**Actual provisions in Annex 5 of Regulation No. 55/01:**

**New text according to doc. GRRF/2016/28:**

**TOWING SYSTEM TOP VIEW – OPERATING MODE according to actual R55.01**

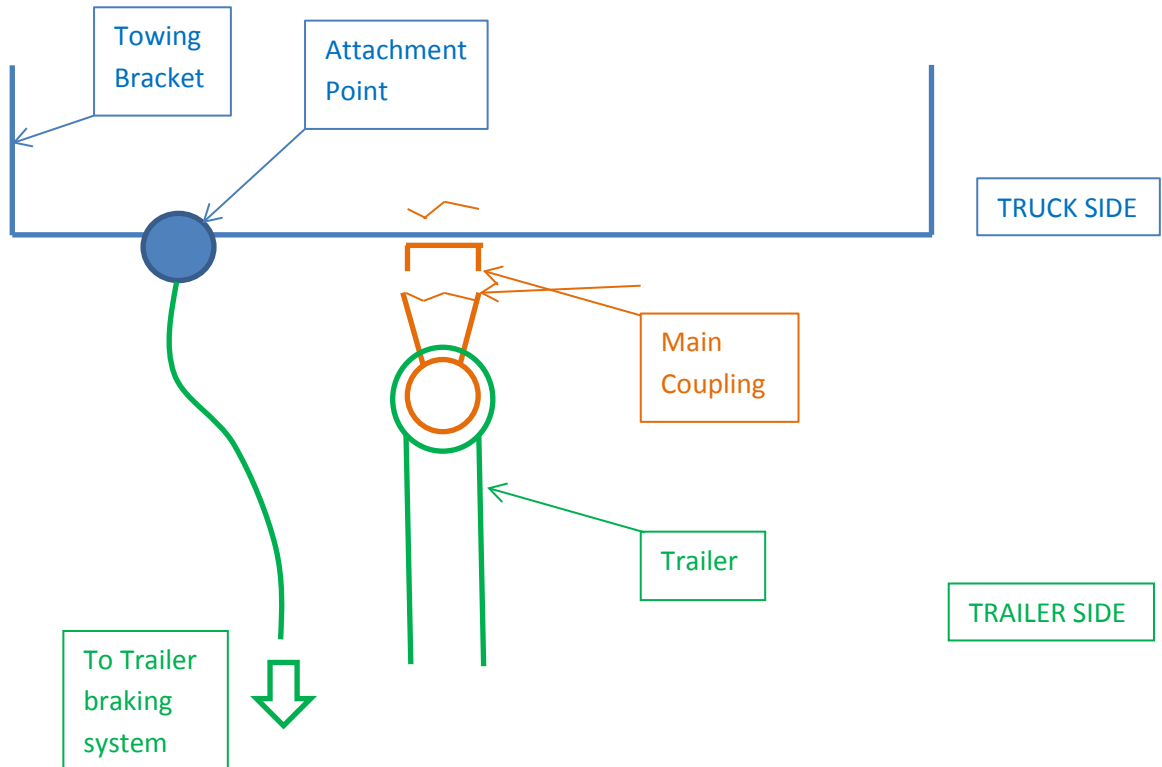
**In the event of main coupling separation, the secondary device (e.g. breakaway cable) will activate the trailer brakes allowing the trailer to stop.**

**TOWING SYSTEM TOP VIEW – MAIN COUPLING FAILURE MODE according to amended R55.01**

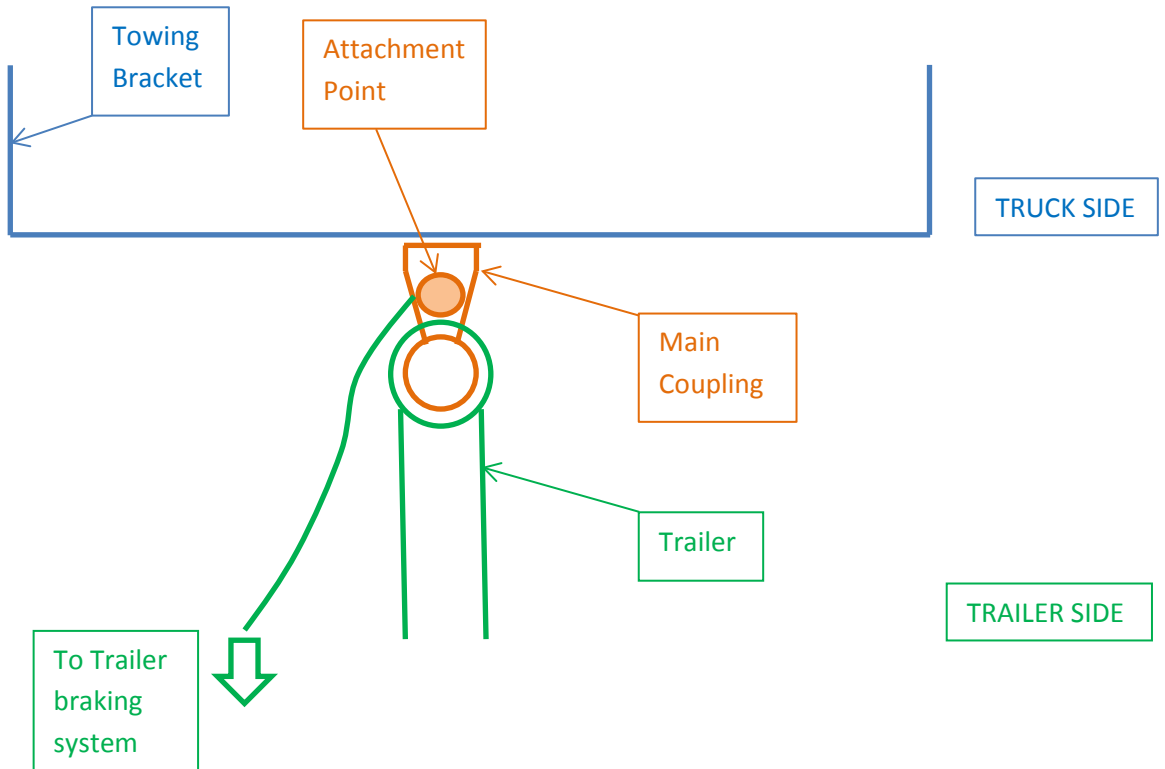
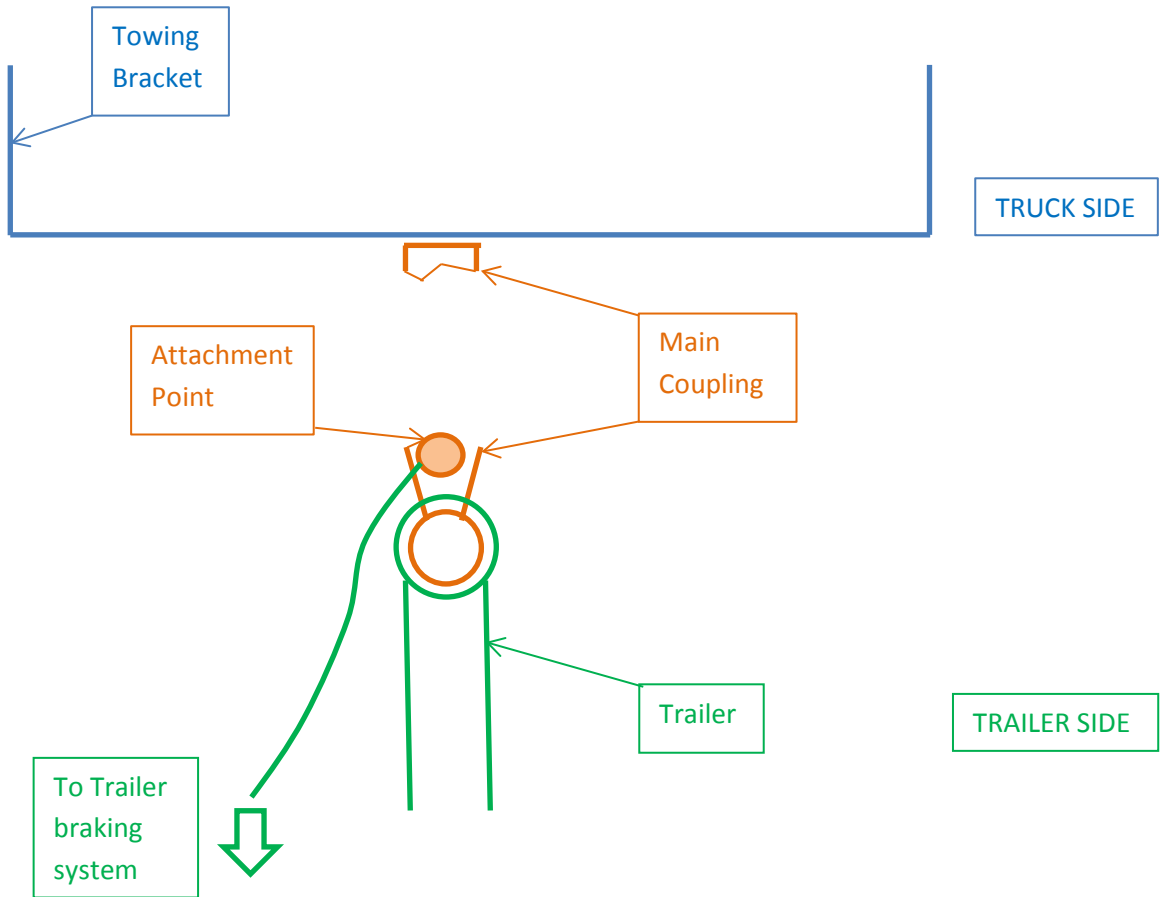
**In the event of main coupling separation, the secondary device (e.g. breakaway cable) WILL NOT be able to activate the trailer brakes and the trailer WILL NOT stop.**
